PRODUCT CHANGE NOTICE

PCN#21-059

MODELS AFFECTED:

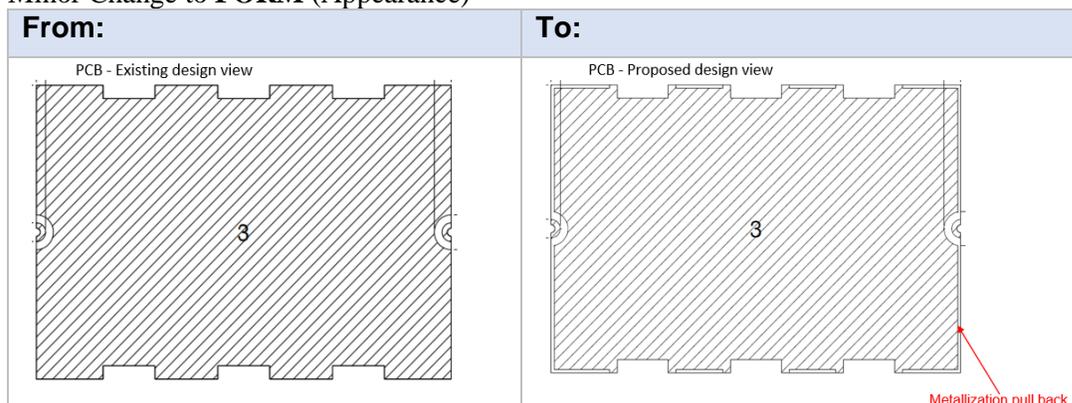
Metal pull-back from PCB edge on bottom side
Refer to www.minicircuits.com for layout drawing 98-PL-652

- No change to **FUNCTION** (Performance), or **FIT** (Dimensions),
- Minor Change to **FORM** (Appearance)
